Additional justification to ECE/TRANS/WP.29/GRBP/2023/18

Proposal for Supplement 27 to UN Regulation No. 54

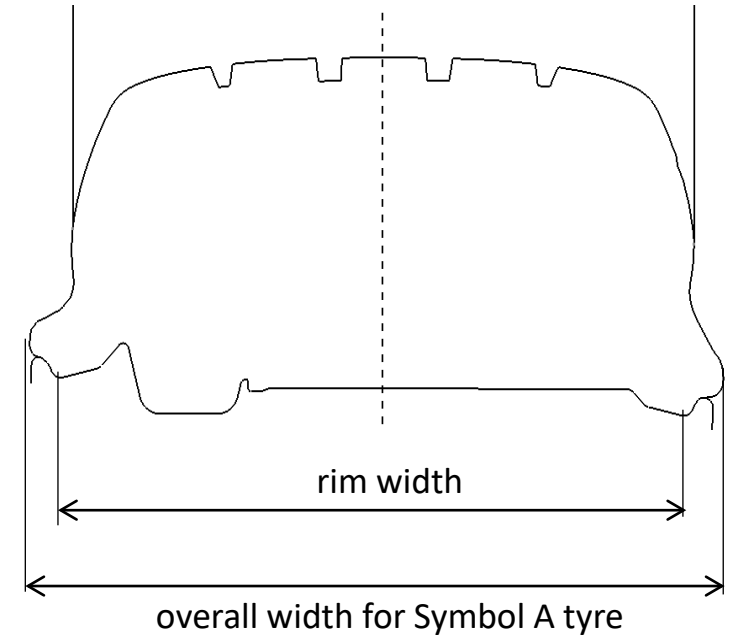
2.13.1. However, in case of tyres identified by the "tyre to rim fitment configuration" (see para. 2.20.5.) symbol "A", it means the area of the tyre which is seating on the rim.

→ The lower sidewall is specific for symbol A tyre with a dedicated tyre to rim configuration

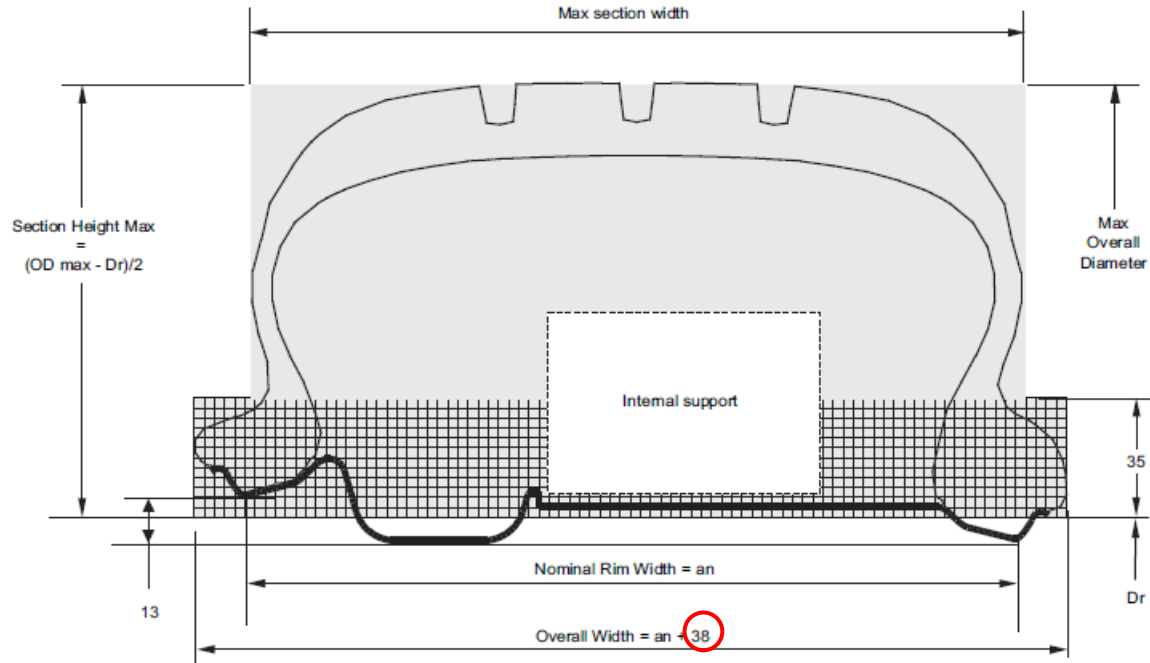
- Problem: not clear that the tolerance mentioned in §6.1.4.2 needs to be added on top of the 27mm referred to in §6.1.4.3 for symbol A tyre.

Proposal: 27mm + 4% → 38mm

Maximum overall width specification clearly includes the tolerance of 4% referred to in §6.1.4.2:

$$(\text{rim width} + 27\text{mm}) \times 1.04 \approx \text{rim width} + 38\text{mm}$$
